AGENDA
DANIA BEACH CITY COMMISSION
REGULAR MEETING
TUESDAY, DECEMBER 10, 2019 - 7:00 PM

A RESOLUTION OF THE CITY COMMISSION OF THE CITY OF DANIA BEACH, FLORIDA, APPROVING THE SITE PLAN AND ALTERNATE PARKING STANDARD (SP-151-19) SUBMITTED BY DANIA LIVE 1748, LLC FOR PROPERTY GENERALLY LOCATED ON THE NORTH SIDE OF STIRLING ROAD BETWEEN BRYAN ROAD AND INTERSTATE 95 WITHIN THE CITY OF DANIA BEACH, FLORIDA, AS LEGALLY DESCRIBED IN EXHIBIT “A,” A COPY OF WHICH IS ATTACHED TO THIS RESOLUTION; PROVIDING FOR CONFLICTS; AND FURTHER, PROVIDING FOR AN EFFECTIVE DATE. *(Community Development)*

A RESOLUTION OF THE CITY COMMISSION OF THE CITY OF DANIA BEACH, FLORIDA, APPROVING THE DEVELOPMENT DESIGN GUIDELINES (DDG) AND SITE PLAN (SP-106-19) SUBMITTED BY STEPHANIE J. TOOTHAKER, ESQ., P.A., ON BEHALF OF PROJECT USA, LLC AND CYMBAL DEVELOPMENT FOR PROPERTY GENERALLY LOCATED ON THE NORTH SIDE OF STIRLING ROAD AND EAST SIDE OF BRYAN ROAD WITHIN THE CITY OF DANIA BEACH, FLORIDA, AS LEGALLY DESCRIBED IN EXHIBIT “A,” A COPY OF WHICH IS ATTACHED TO THIS RESOLUTION; PROVIDING FOR CONFLICTS; AND FURTHER, PROVIDING FOR AN EFFECTIVE DATE. *(Community Development)*

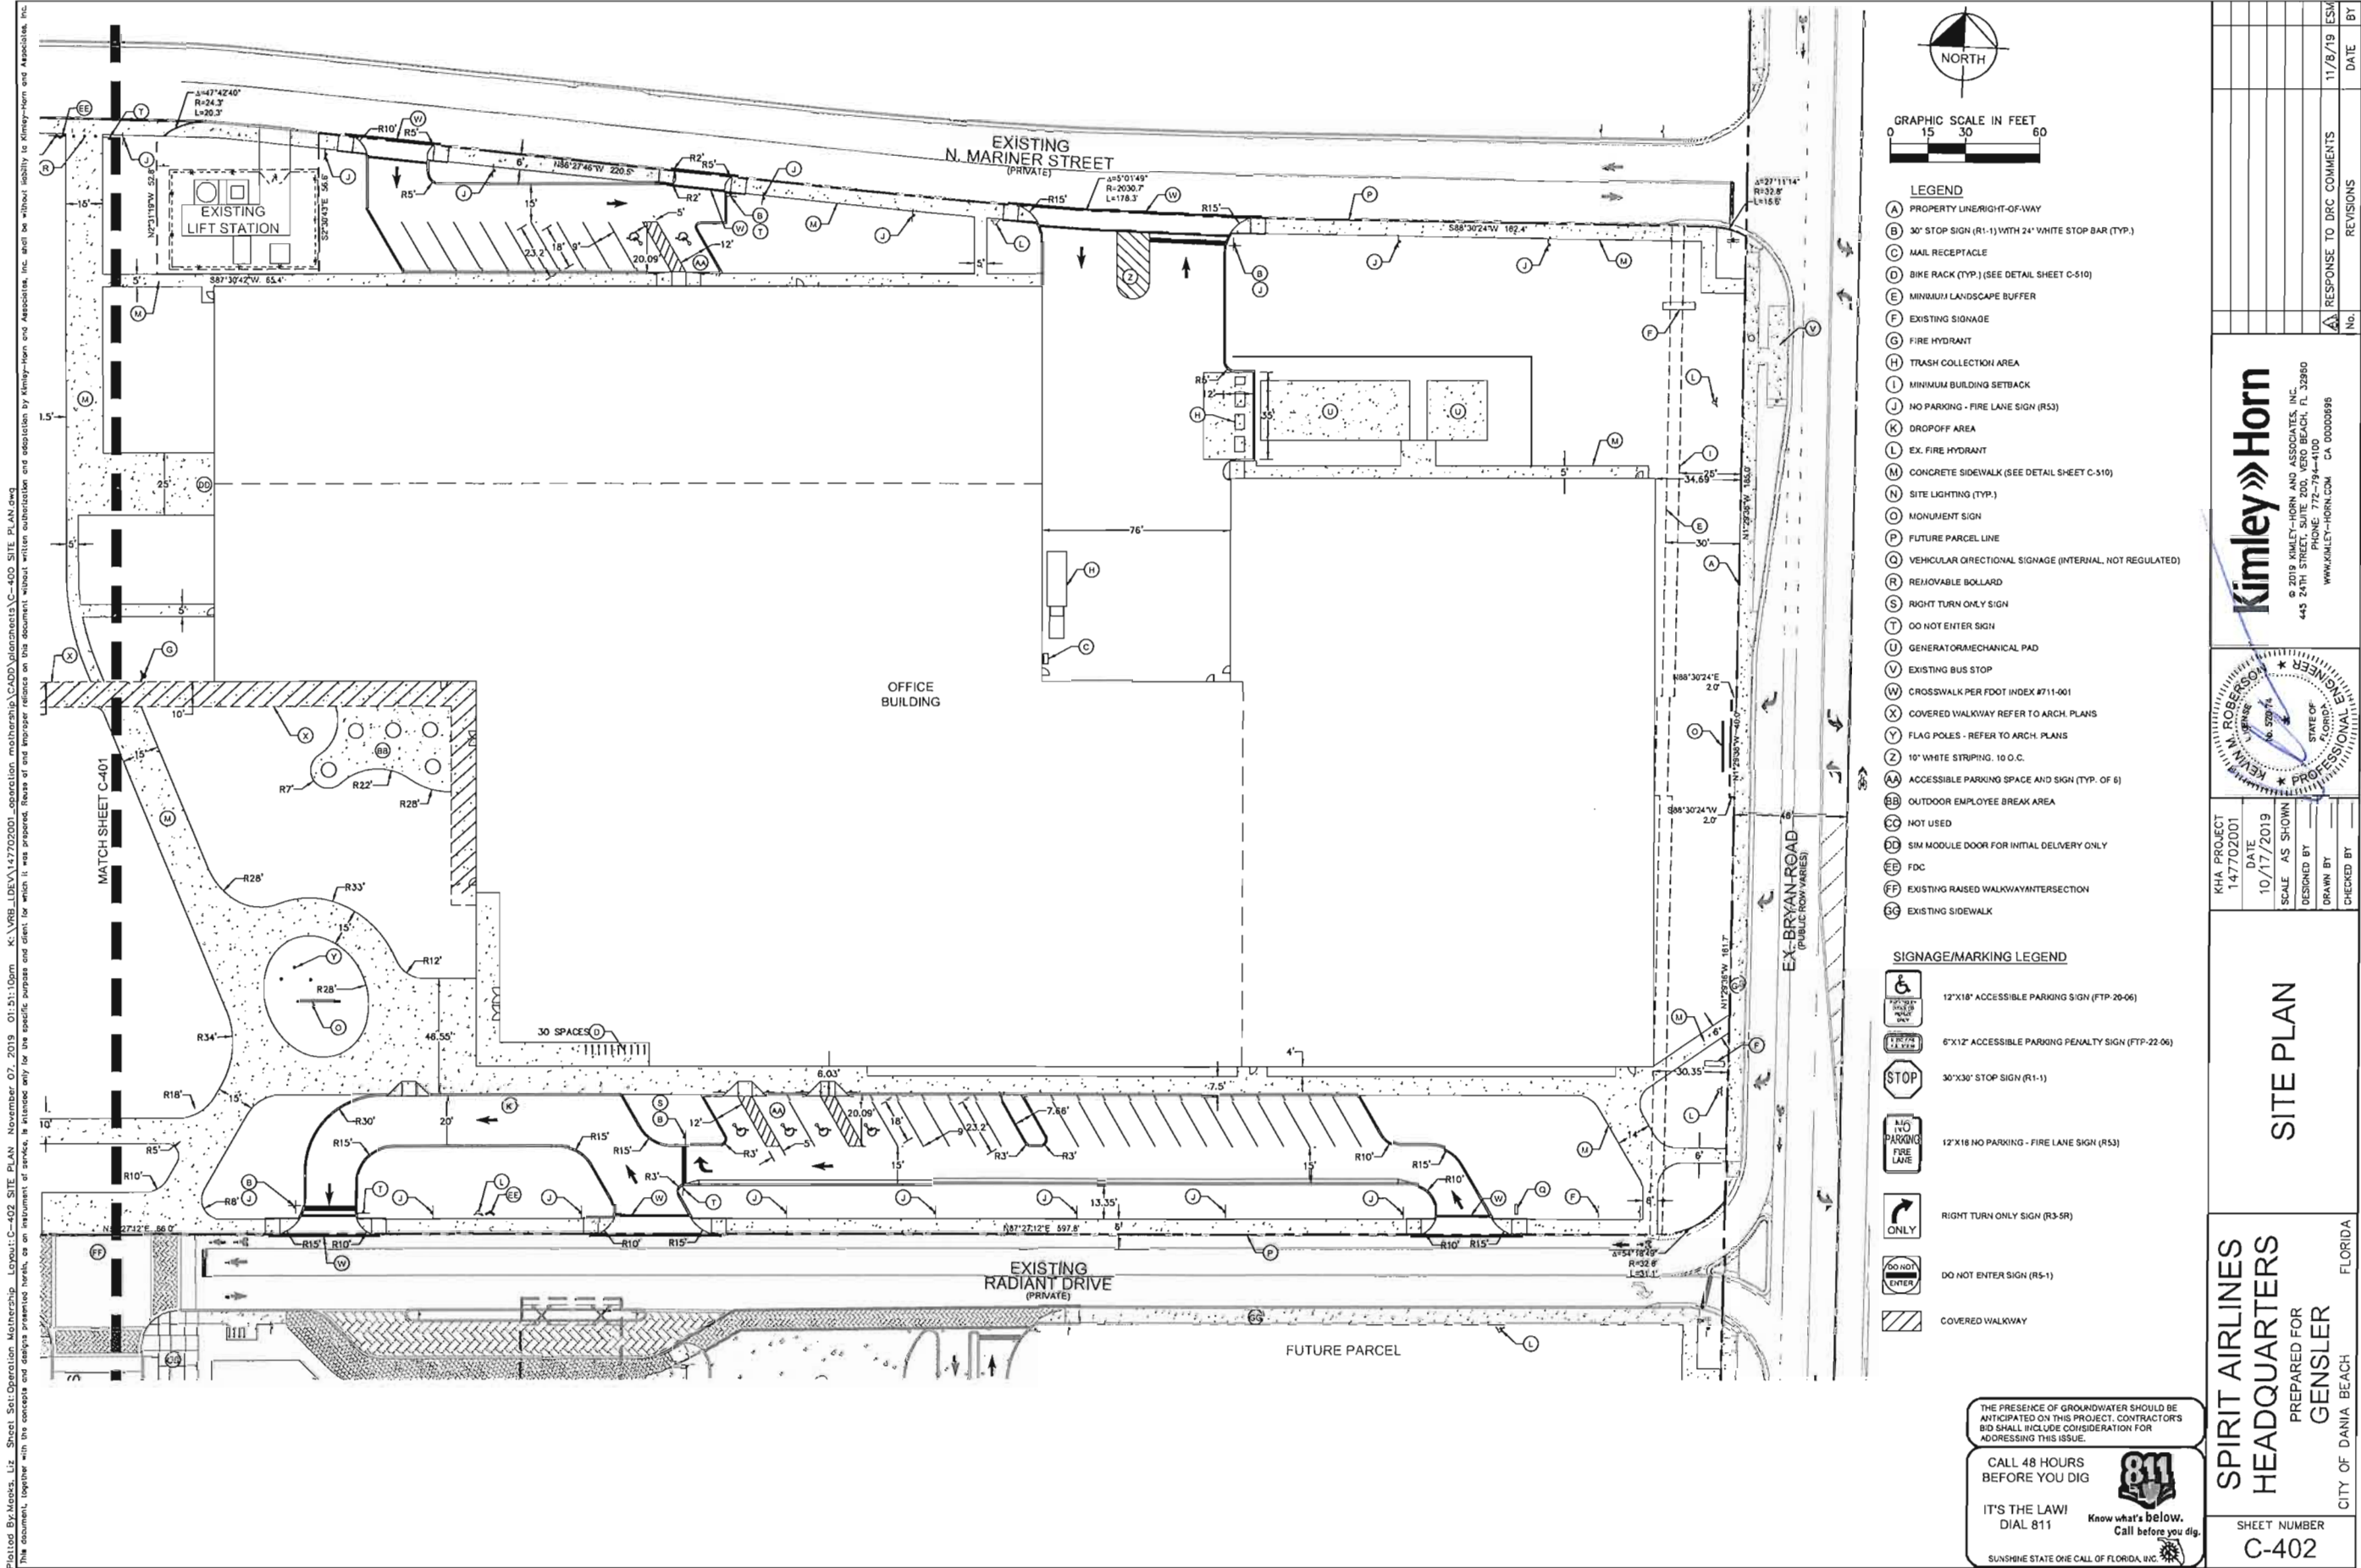
39. Per Section (7) Parking (8) 45 degree parking shall be a minimum 9' X 19'1", 60 degree parking shall be a minimum 9' X 20'1". See images in DDG. Revise Sheet C-402 accordingly (Planning).

Comment 9) Per Section (7) Parking (8) 45 degree parking shall be a minimum 9' X 19'1", 60 degree parking shall be a minimum 9' X 20'1". See images in DDG. Revise Sheet C-402 accordingly.

Acknowledged, please see updated dimensions on Sheet C-402 that was submitted on 11/8.

Response 9) *Please see updated dimensions on Sheet C-402.*

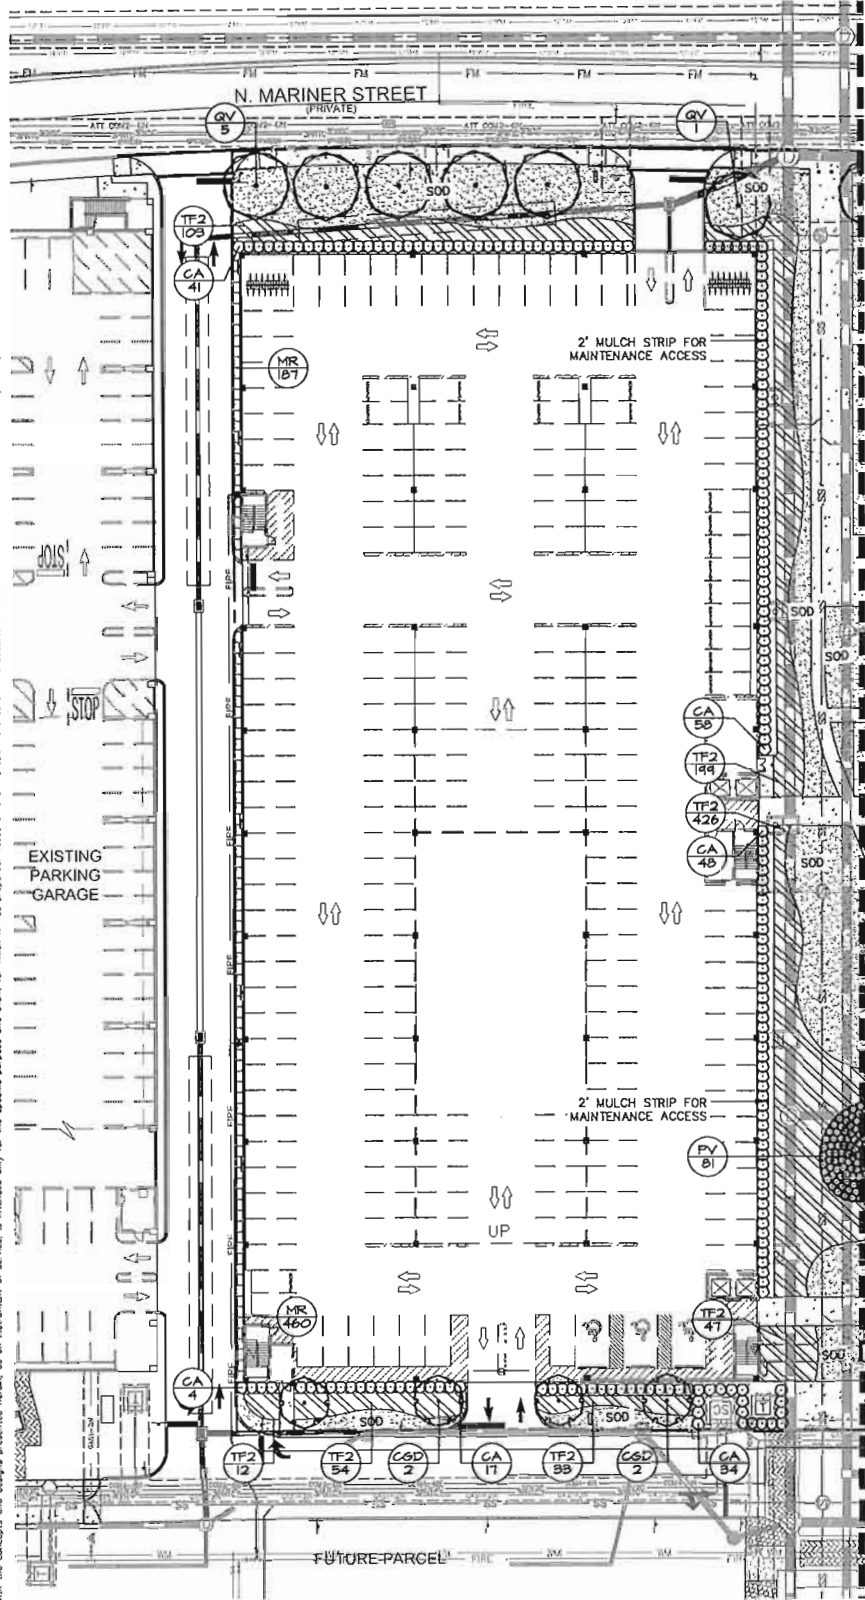
Comment 1) Add Non-Native designation to Bridalveil tree and St. Augustine sod in the schedule on sheet L-100

- 1) Add Non-Native designation to Bridalveil tree and St. Augustine sod in the schedule on sheet L-100
- 2) Revise the Compliance chart on L-100 to reference the full plant palette to match DDG requirements (i.e. not just trees).
- 3) Change native status of *Arachis glabrata* to Non-native.
- 4) Please provide a complete landscape data table which outlines acreages/square footages of applicable greenspace vs VUA and structure, and include all DDG guidelines as well as applicable City code requirements where no DDG alternative was specified, and indicate the quantity required vs the quantity provided for each.

Response 5) Please refer to the City of Dania Beach Compliance Chart on Sheet L-100 for the min. and max. percentage breakdowns as outlined in 275-190 (D), (E), (F), & (G).

Response 6) Refer to note 16 in the "Planting Notes" on Sheet L-100 for reference to Section 275-190(I).

Refer to DDG Code Compliance Table on Sheet L-100 for itemized code labelling.
- Comment 8)

Refer to the DDG Code Compliance Table on Sheet L-100 for revised section title to "Non-Buffer Areas" and information regarding VUA area versus Non-VUA area.
- Comment 11)

Per DDG (6)2 this requirement is a standard that is applied and satisfied on the overall Dania Pointe and is not required for each block, parcel, or individual development. Please refer to DDG Code Compliance Table on Sheet L-100 for additional information.
- Comment 12)

Refer to DDG Code Compliance Table on Sheet L-100 for the added requirement column next to the provided column. The table alignment has been adjusted.
- Comment 13)

PROJECT NO.
19-040
SHEET:
TS-1 of 1

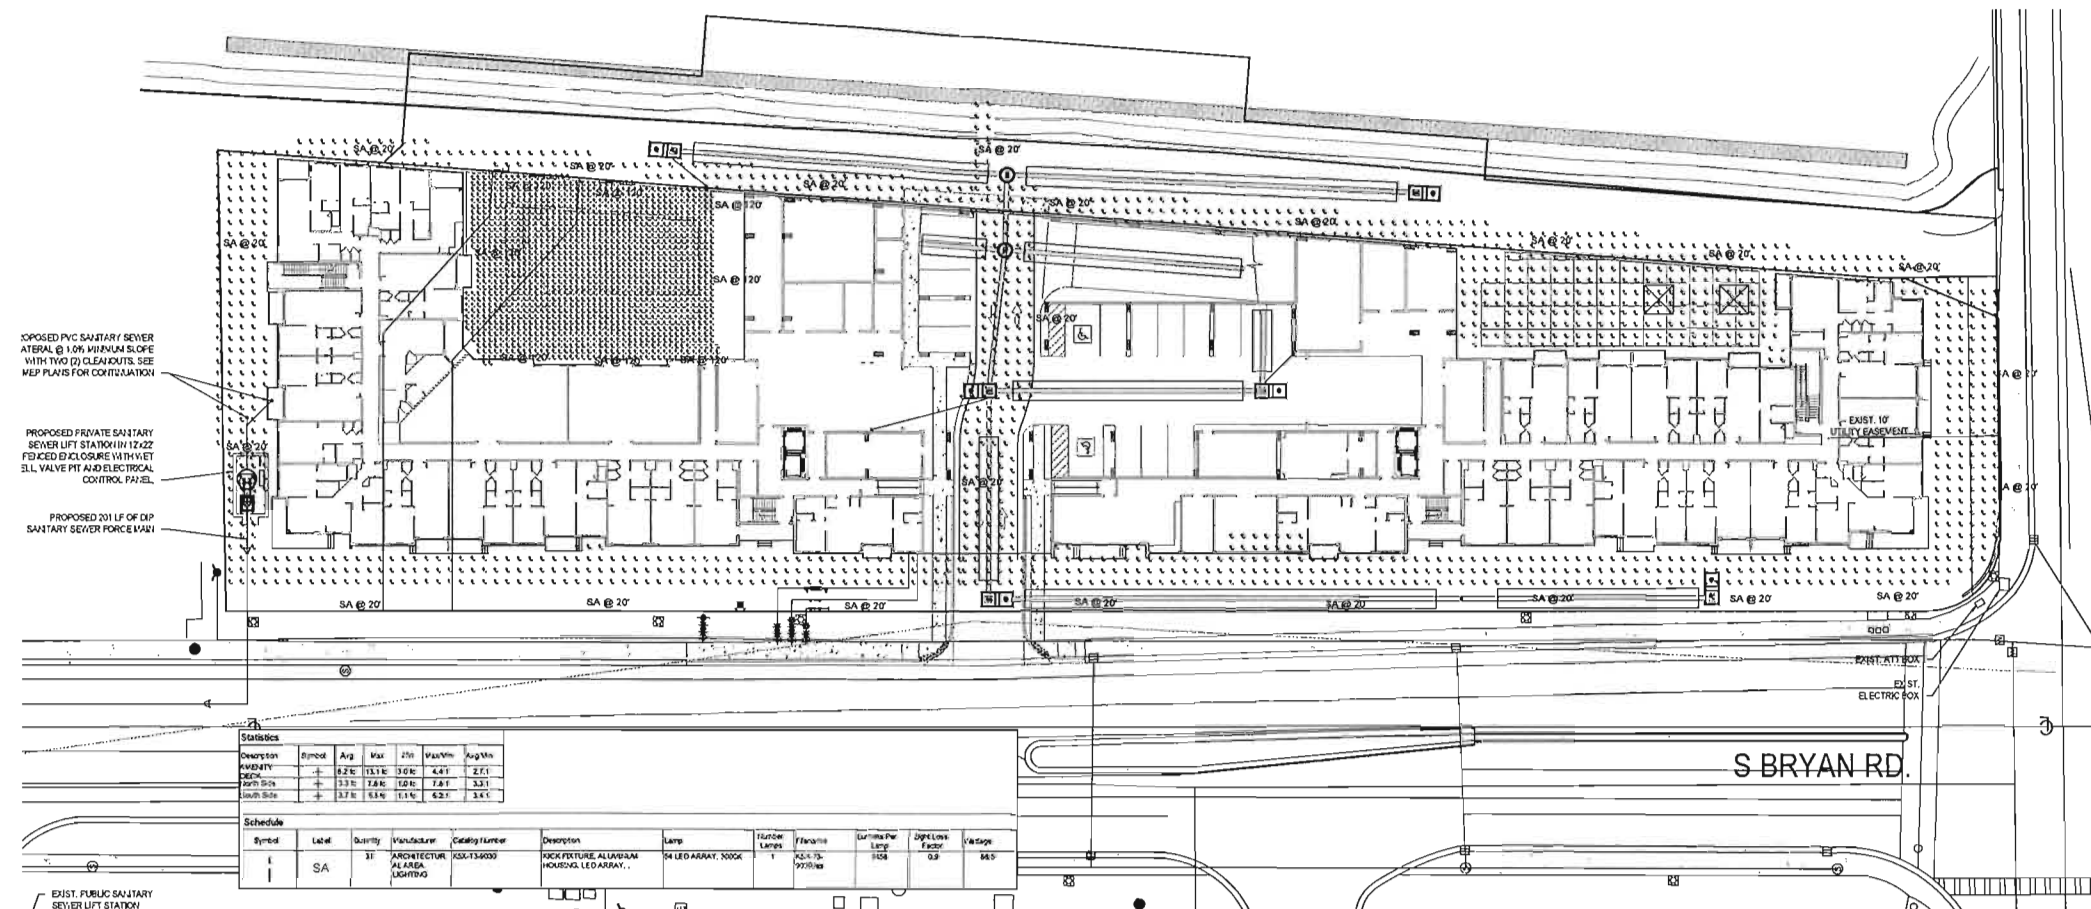
4. Repeat comment: Provide the specimen value on sheet TS-1 for the specimen strangler fig proposed for removal. The specimen tree appraisal formula can be found in Sec. 825-140(C)(2).

4. Repeat comment: Provide the specimen value on sheet TS-1 for the specimen strangler fig proposed for removal. The specimen tree appraisal formula can be found in Sec. 825-140(C)(2). An arborist report was not submitted in this plan set and the previously submitted arborist report did not include a specimen tree appraisal value (Landscaping).

- 1) Repeat comment: Provide the specimen value on sheet TS-1 for the specimen strangler fig proposed for removal. The specimen tree appraisal formula can be found in Sec. 825-140(C)(2). An arborist report was not submitted in this plan set and the previously submitted arborist report did not include a specimen tree appraisal value.

DATE: 11-06-19
SCALE: 1" = 30'
DRAWING BY: AD
DESIGNED BY: AD

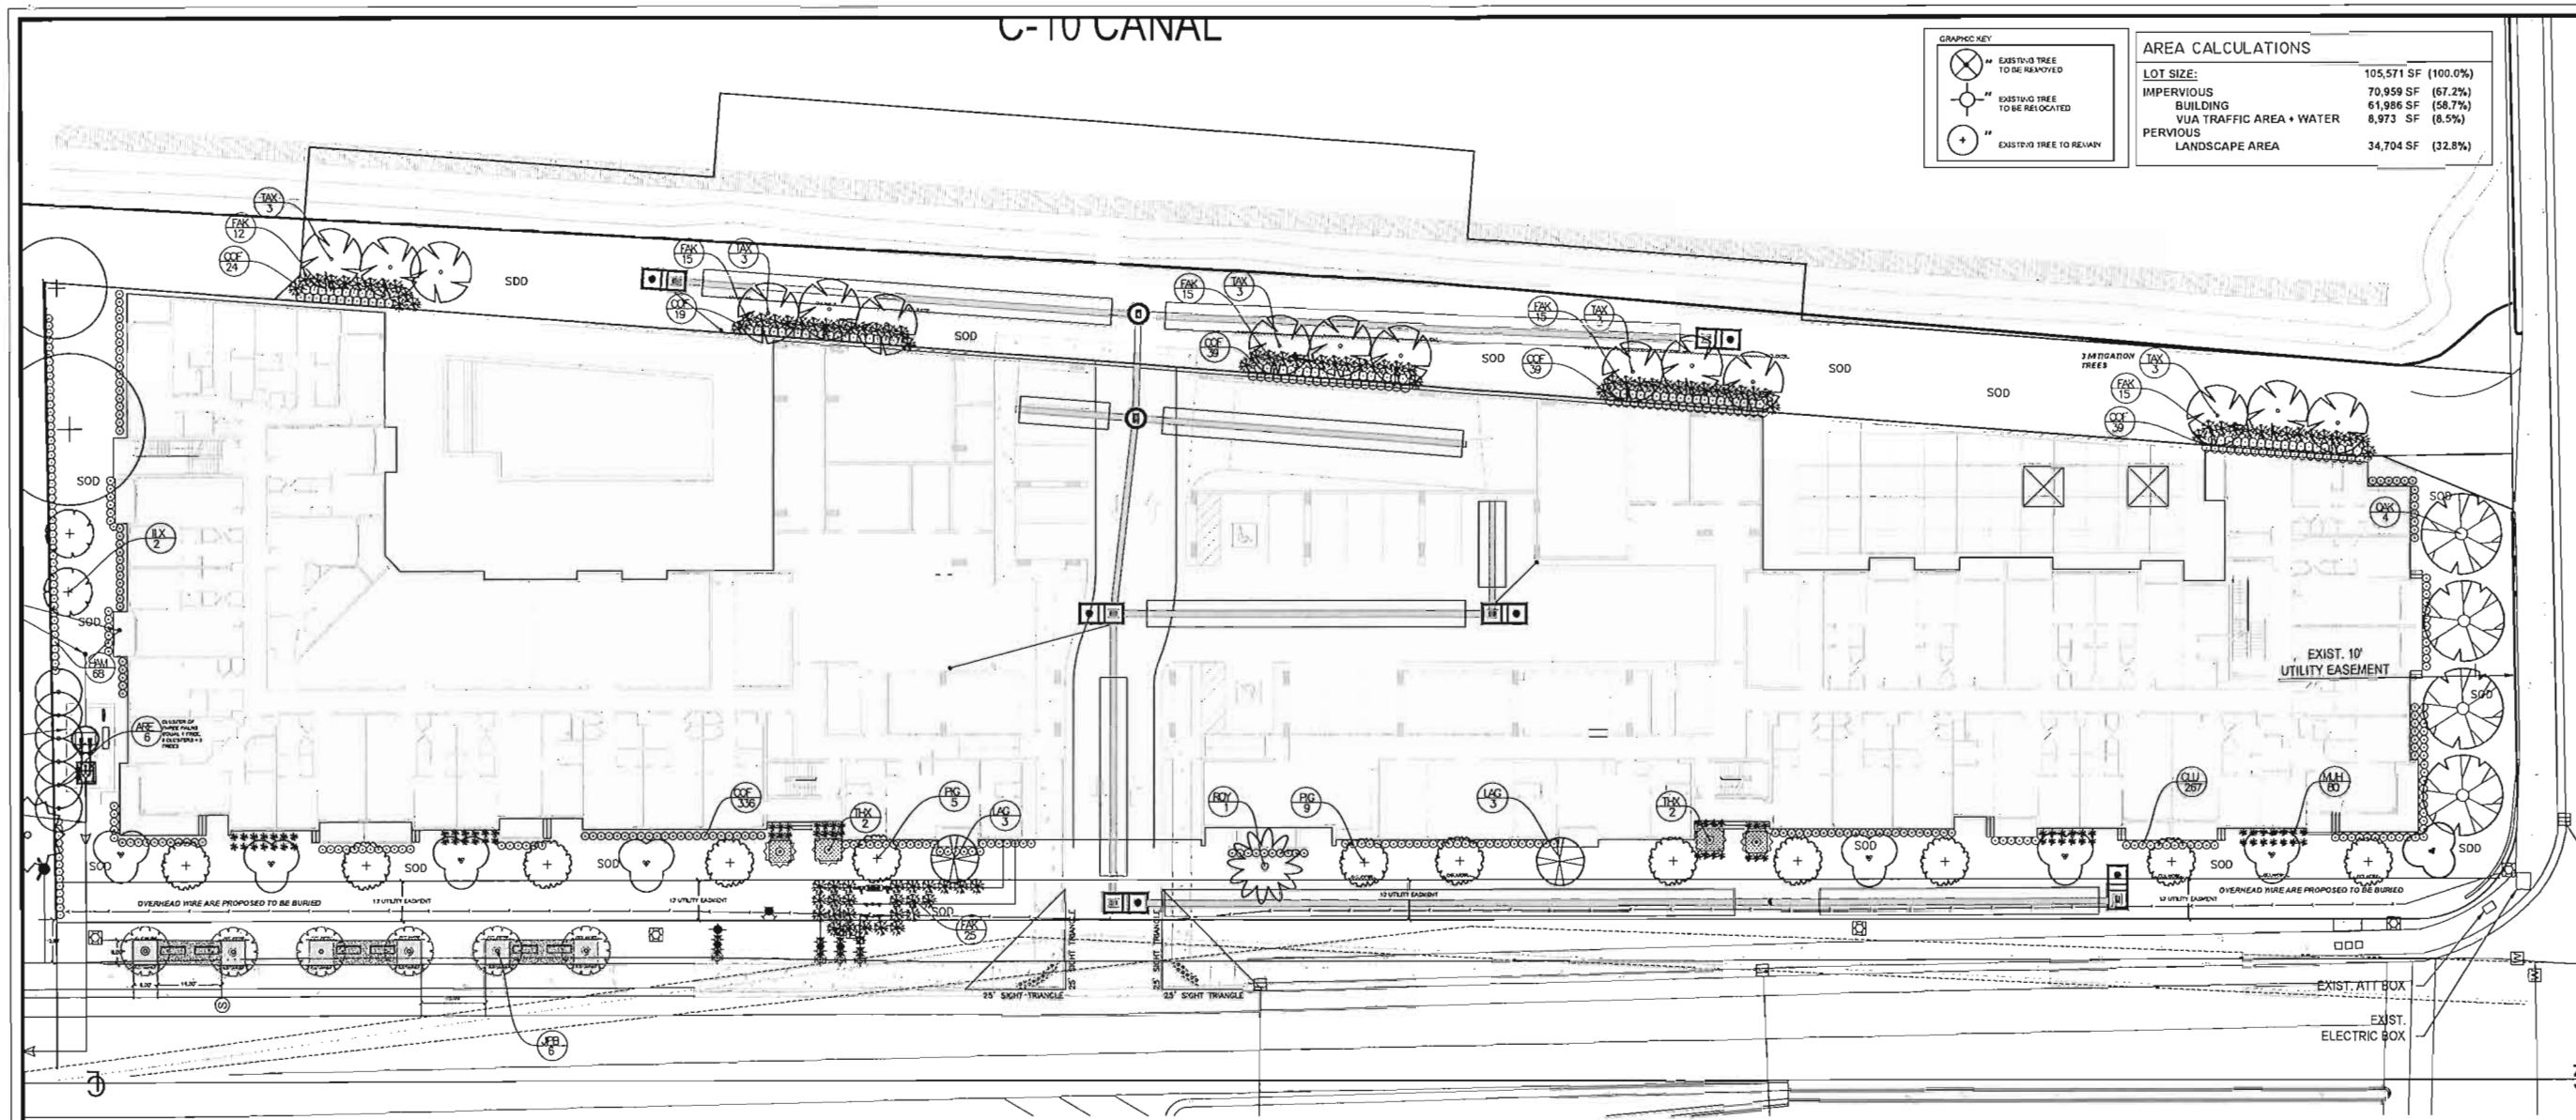
6. Show the mangrove and native species canopy to remain along the canal on the landscape plan on sheet LP-1 (Landscape).
7. Include the Brazilian pepper and tropical almond canopy to be removed near the canal in the overall mitigation calculations. Show how these trees will be mitigated (Landscape).

6. Show the mangrove and native species canopy to remain along the canal on the landscape plan on sheet LP-1 (Landscape).
7. Include the Brazilian pepper and tropical almond canopy to be removed near the canal in the overall mitigation calculations. Show how these trees will be mitigated (Landscape).

- 3) Show the mangrove and native species canopy to remain along the canal on the landscape plan on sheet LP-1.
- 4) Include the Brazilian pepper and tropical almond canopy to be removed near the canal in the overall mitigation calculations. Show how these trees will be mitigated.
